# Access Compliance Report

## Public Rights-of-Way

Intersection ID: 17974	Main Street: OLD_PINEVILLE_RD	Cross Street: SPRINGBROOK_RD	Location: SW
ADA ID: 877840DBAEEC	Ramp Type: PerpDiag	Initial Pass/Fail: Fail	Overall Compliance: No
Severity Score: 10			
Codes/Mitigation Info/Possible Solution		Field Measurements/Component Compliance

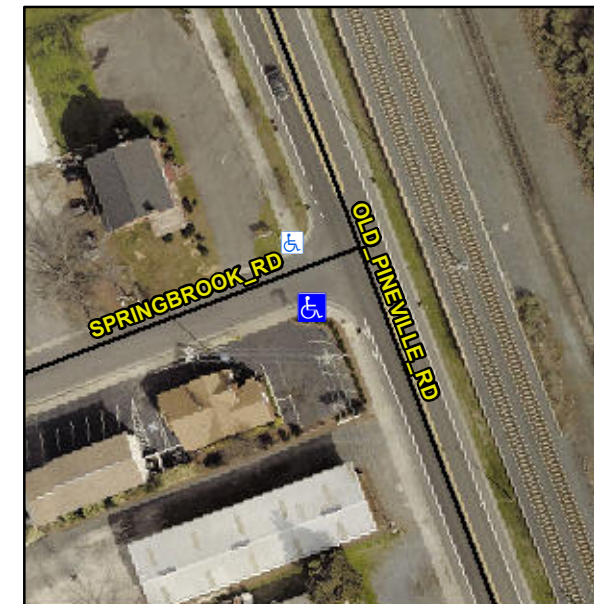
**Not Found, R304.5.1, R304.5.3**

Compliance	Description	Data	Compliance	Description	Data
N/A	Ramp Length (in)	72.0	Yes	Ramp Slope (%)	7.7
No	Ramp Width (in)	46.0	No	Ramp XSlope (%)	2.5
N/A	Flare Type LT	N/A	N/A	Flare Type RT	N/A
N/A	Flare Slope LT (%)	N/A	N/A	Flare Slope RT (%)	N/A
N/A	Flare Traversable LT?	N/A	N/A	Flare Traversable RT?	N/A
N/A	Landing Length (in)	N/A	N/A	DWS Provided?	N/A
N/A	Landing Width (in)	N/A	N/A	DWS Contrast?	N/A
N/A	Landing Slope (%)	N/A	N/A	DWS Length (in)	N/A
N/A	Landing X Slope (%)	N/A	N/A	DWS Full Width?	N/A
N/A	Landing Curb? (Y/N)	N/A	N/A	DWS Offset (in)	N/A
N/A	Shared Landing?	N/A			
N/A	Gutter Ponding?	N/A	N/A	Gutter Slope (%)	N/A
N/A	Gutter Lip Ht (in)	N/A	N/A	Gutter X Slope (%)	N/A
N/A	Painted X Walk1?	No	N/A	Painted X Walk2?	No
	X Walk 1 Direction	To E		X Walk 2 Direction	To N
N/A	X Walk 1 Width (in)	N/A	N/A	X Walk 2 Width (in)	N/A
	X Walk 1 Slope (%)	1.6		X Walk 2 Slope (%)	0.0
	X Walk 1 X Slope (%)	1.5		X Walk 2 X Slope (%)	2.5

**Remove & Replace Curb Ramp With Two New Directional Ramps or Equivalent.**
